VIRGINIA ELECTRIC AND POWER COMPANY
NORTH ANNA POWER STATION UNITS 1 AND 2
SIX-MONTH STATUS REPORT IN RESPONSE TO MARCH 12, 2012 COMMISSION
ORDER MODIFYING LICENSES WITH REGARD TO REQUIREMENTS FOR
MITIGATION STRATEGIES FOR BEYOND-DESIGN-BASIS EXTERNAL EVENTS
(ORDER NUMBER EA-12-049)

**Six Month Status Report for the Implementation of Order EA-12-049
Order Modifying Licenses with Regard to Requirements for Mitigation Strategies for
Beyond-Design-Basis External Events**

**North Anna Power Station Units 1 and 2
Virginia Electric and Power Company (Dominion)**

FIGURE 8 (AUGUST 2013 UPDATE)
120/240 AND 480 VAC
ELECTRICAL GENERATOR DEPLOYMENT LAYOUT
NORTH ANNA POWER STATION

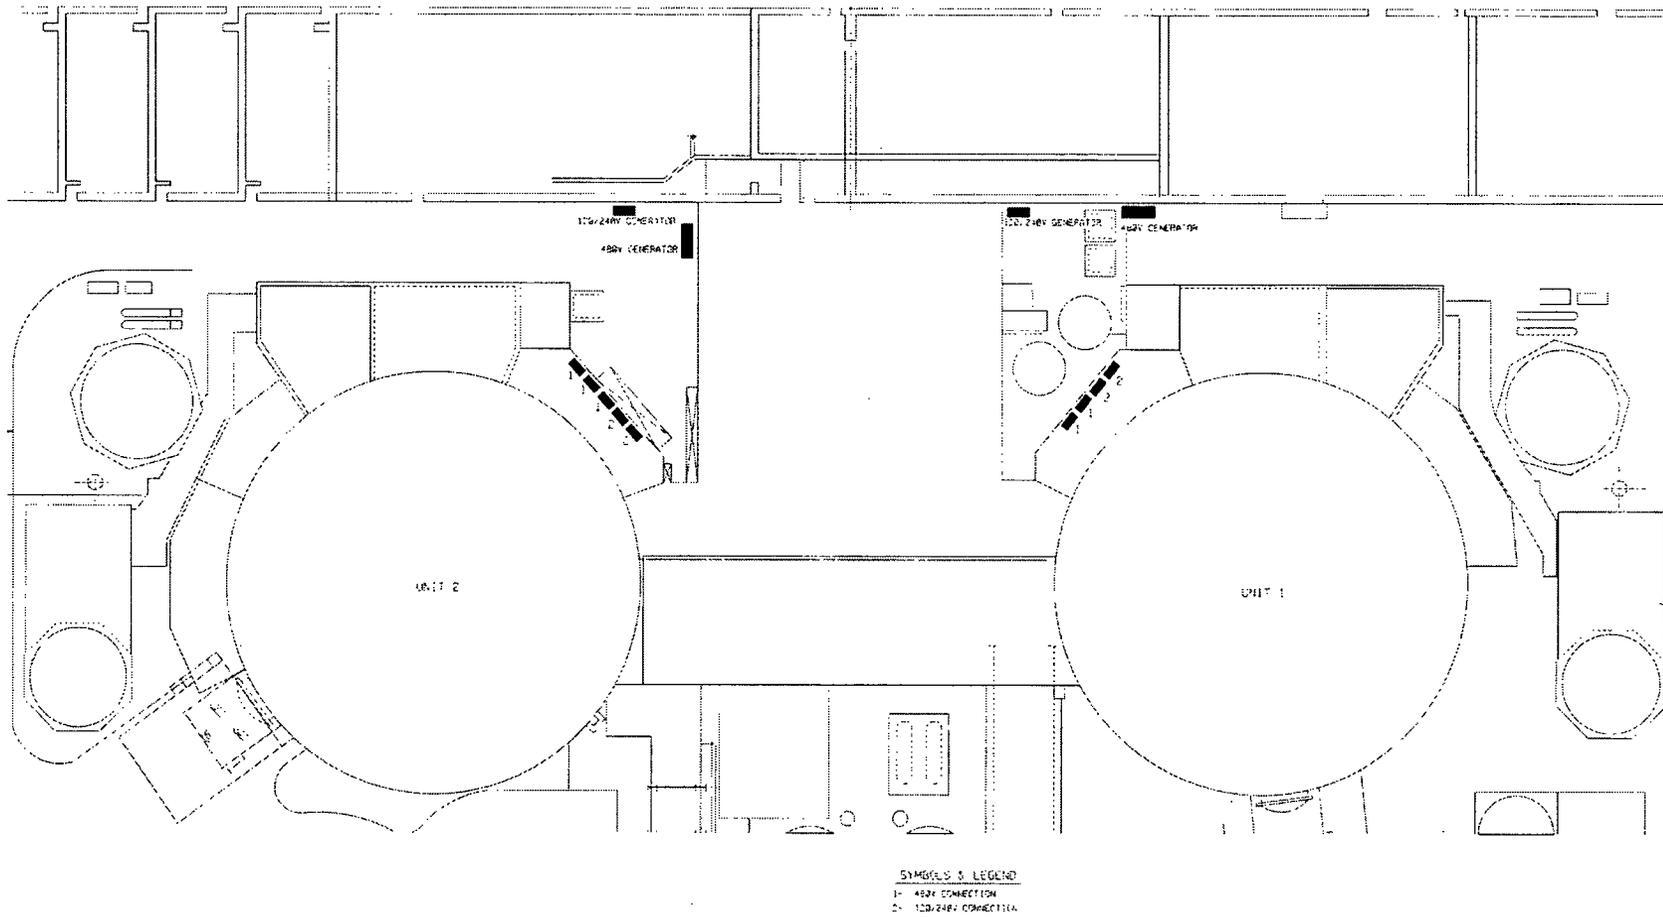
- c) Details of the strategy for the portable diesel generators (DGs) used to re-power the 120VAC vital bus circuits, as described in Section F1.2 – PWR Portable Equipment Phase 2, have changed for North Anna Units 1 and 2. A single 120/240VAC DG per unit will be sized to accommodate the necessary electrical loads for that unit and will power both BDB distribution panels for that unit. Thus, the deployment of two 120/240VAC DGs per unit as shown in Figure 7 of the previously submitted OIP is no longer being pursued, and a revised Figure 7 is attached. Figure 8 is revised to show the location of the single 120/240VAC DG for each unit and the location of the associated unit's connection receptacles and is also attached. Figure 10 was a typical schematic of the connections from one of two 120/240VAC DGs. A revised Figure 10 showing the current connections for the 120/240VAC DG (Unit 1 only) is attached. A spare 120/240VAC DG will be purchased; however, as stated in the OIP, the 480VAC DG is considered the alternate re-powering source for instrumentation.

SEE FIGURE 7B FOR STAGING LOCATIONS OF THE 480V GENERATORS.
THERE ARE NO TIE INSTALLED RECEIPTILES FOR THE 480V CONNECTIONS.
